Additional Information Required, GW Data 2024, Parcel 122, M2015-033

**Re: Additional Information Required, Annual Groundwater Level Data for 2023-2024,
Parcel 122 – Resource Development Project, Permit No. M-2015-033**

VARRA - BEARSON RESOURCE PIEZOMETER MAP
WELD COUNTY, COLORADO

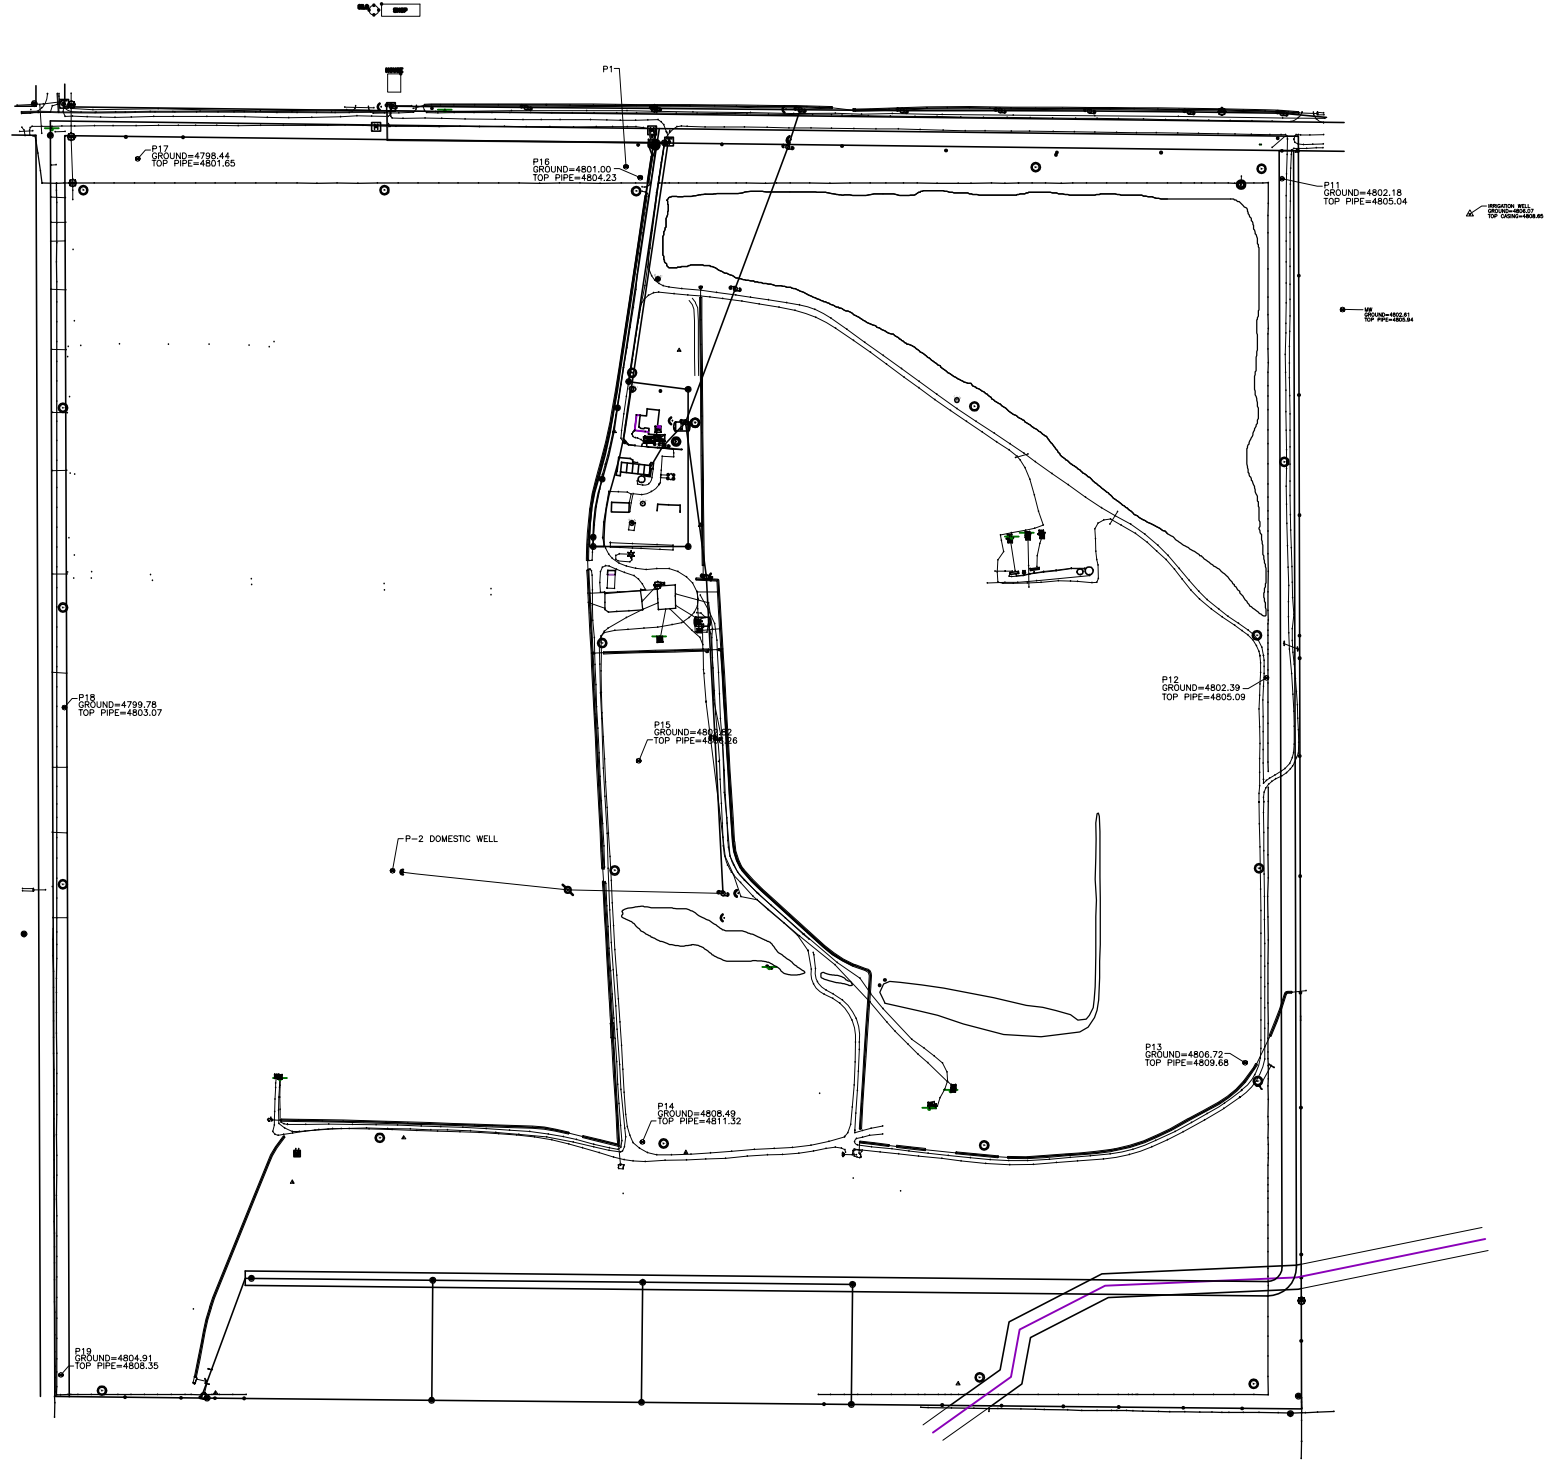
As part of this review the Division looked at the Exhibit G – Water Resources Map, submitted in April 2024, and was unable to locate all the piezometers contained in the groundwater level submittal. Please provide an updated location map showing the locations of all piezometers and monitoring locations at the site.

4. As part of this review the Division looked at the Exhibit G – Water Resources Map, submitted in April 2024, and was unable to locate all the piezometers contained in the groundwater level submittal. Please provide an updated location map showing the locations of all piezometers and monitoring locations at the site.

Please see the attached map. You will notice P3 is not on the map, as it was located off site and P1 was co-located with P16. P2 was an older well that was mined through.

All Charts begin in January of 2022 with monthly values following with the exception of P17 which has additional weekly values for the first 6 months of 2022

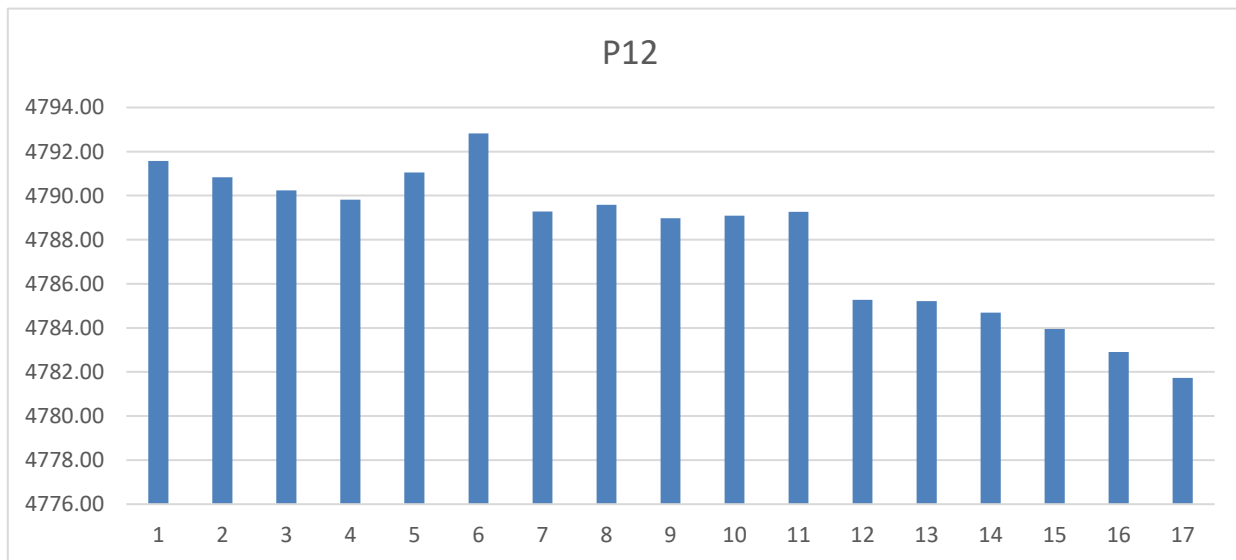
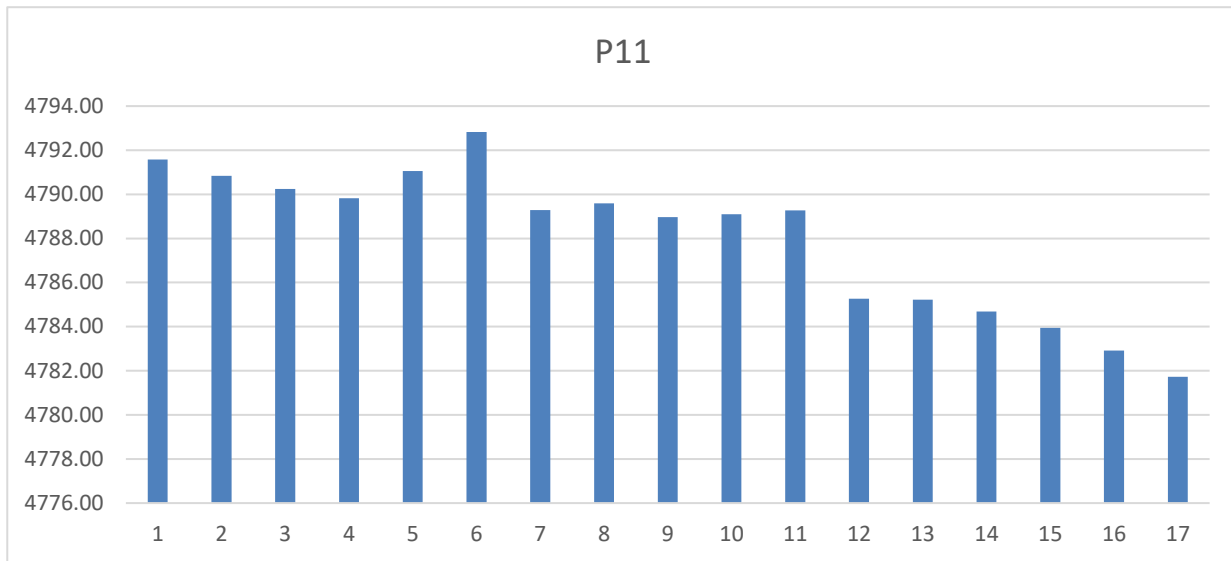
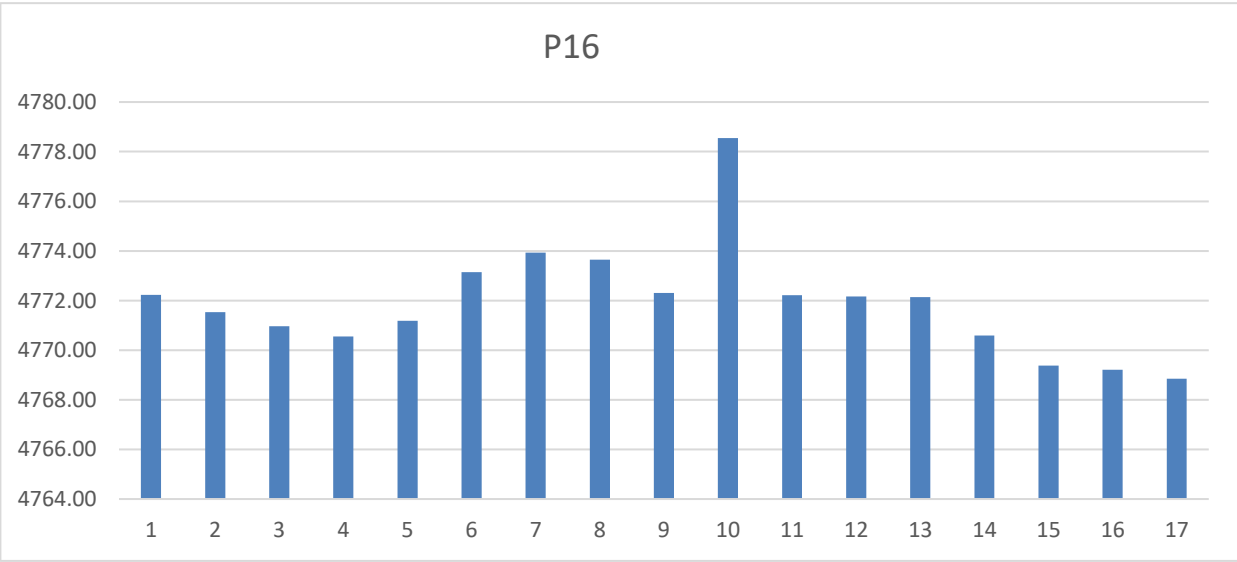
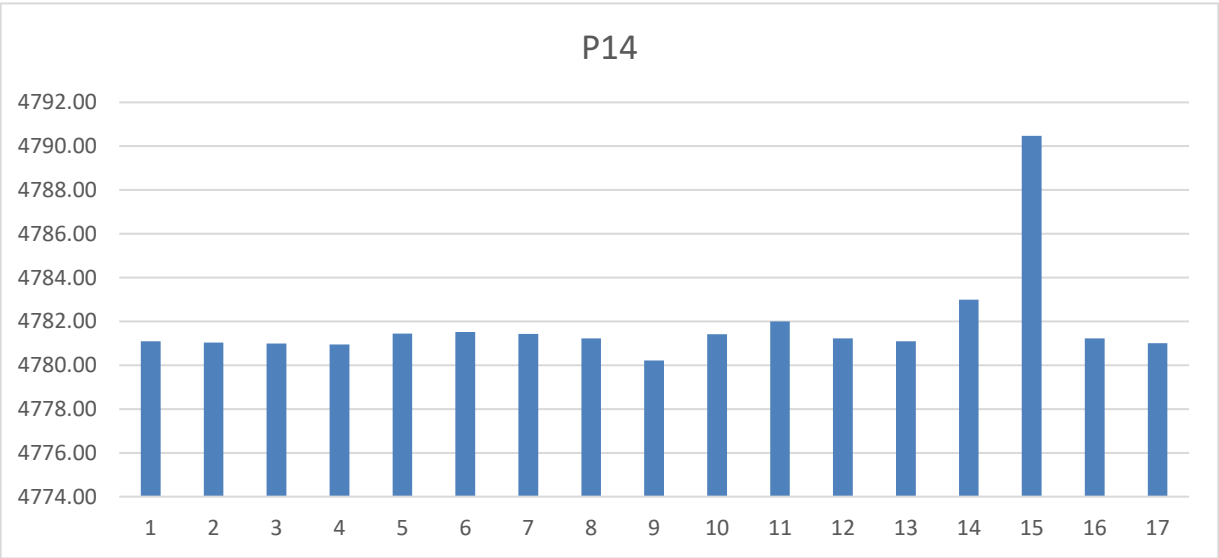
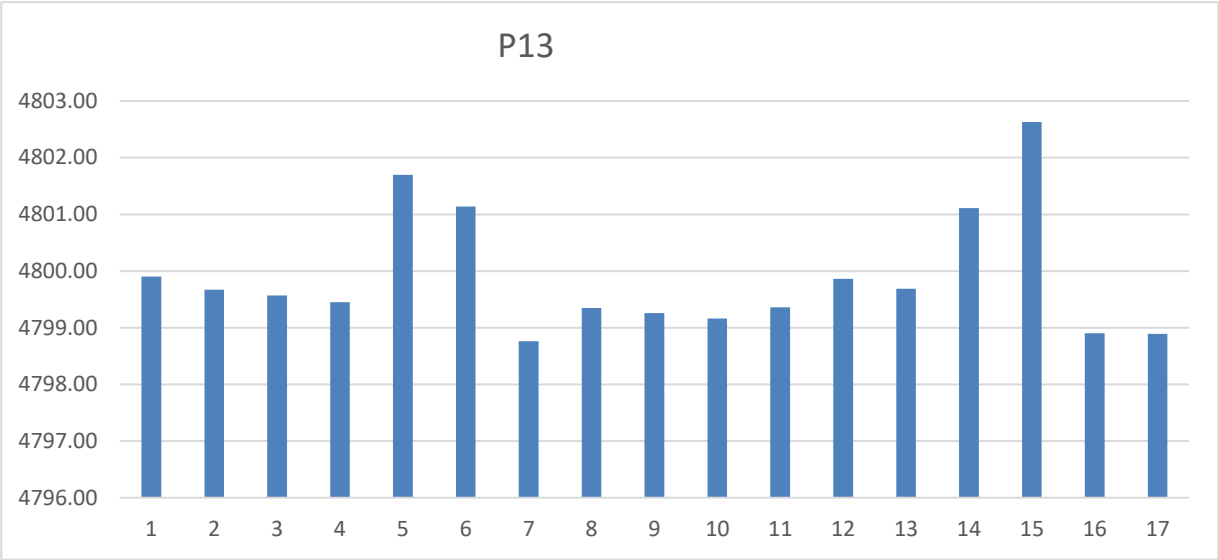
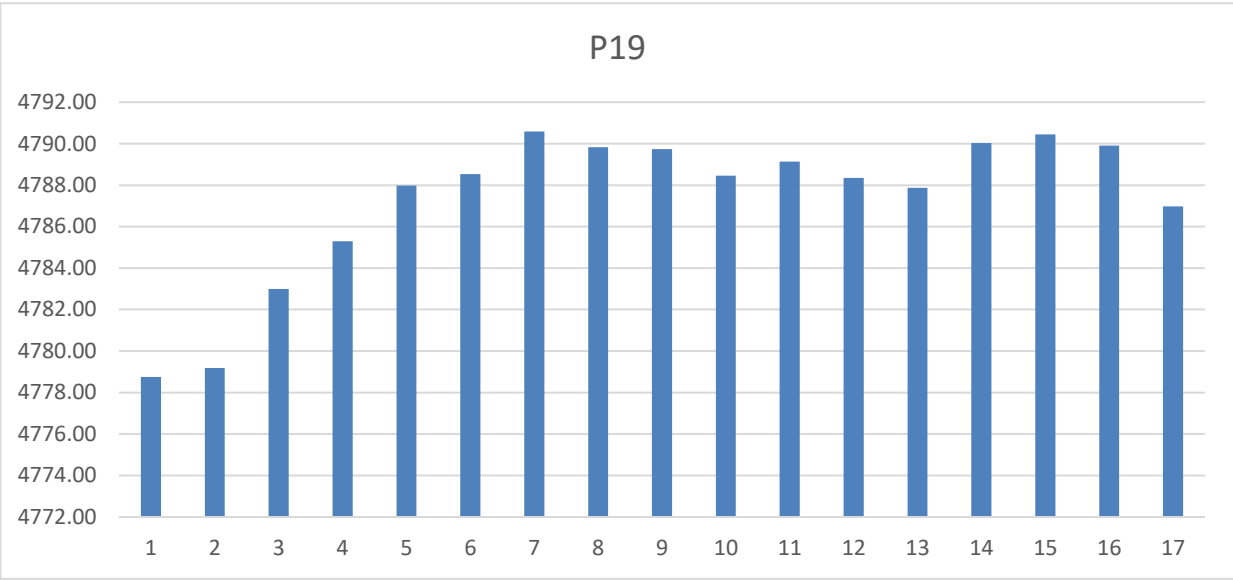
Provide a graph or graphs for groundwater levels for each location that depict trends over the last two (2) years

5. Provide a graph or graphs for groundwater levels for each location that depict trends over the last two (2) years.

Please see the attached .pdf labeled GW Graph 2022-2024

More data points exist for the P17 well due to additional monitoring during 2022
